Application for "Other Business" Cobb County, Georgia

OB-056-2017

State specifically the need or reason(s) for Other Business: To Amend the
SITE Plan Approved By zoning

DB-056-2017 Proposed Site plan.

SURVEY AND ZONING PLAN FOR:
SUE E. WADSWORTH

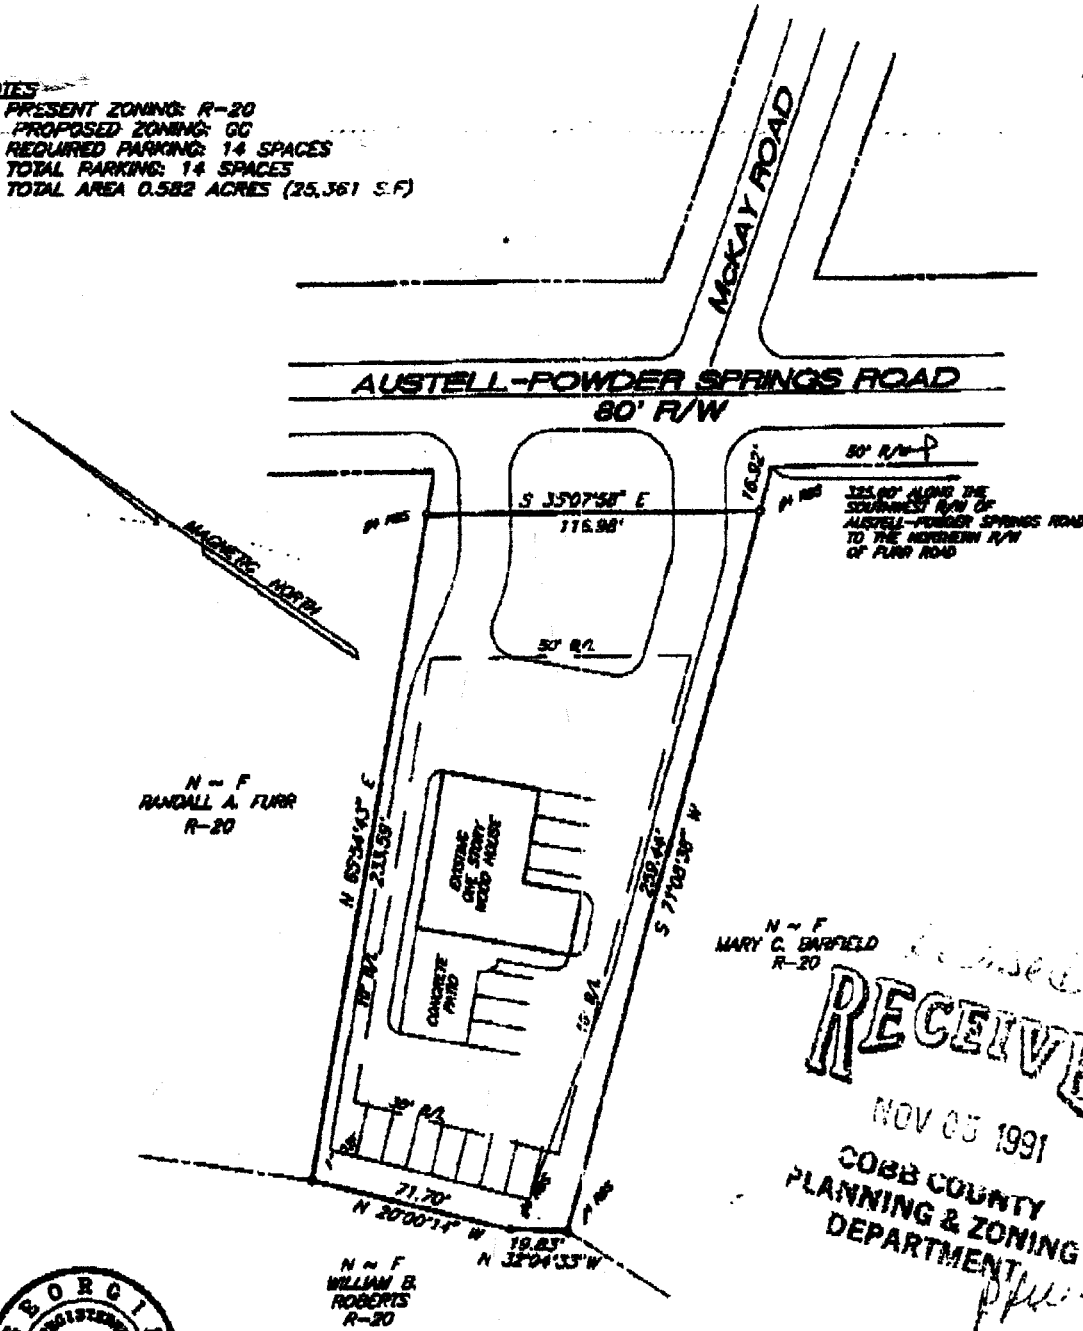
- See letter of agreeable stipulations submitted by Garvis Sams, Jr. and dated October 24, 1991 (exhibit).
- No major repairs on site.
- Revised site plan to indicate the location of two existing driveways.

The site has two existing gravel driveways which access Austell/Powder Springs Road. The proposed driveway shown on the submitted site plan needs to align with McKay Road.

1. Recommend Austell-Powder Springs Road be brought up to minimum standards in accordance with the Cobb County Major Thoroughfare Plan and as required in Standards for Residential and Commercial Development.
2. One driveway to serve the property, which must be paved 25 feet (minimum) from the edge of the roadway into the site.
3. Georgia Department of Transportation permit is required.
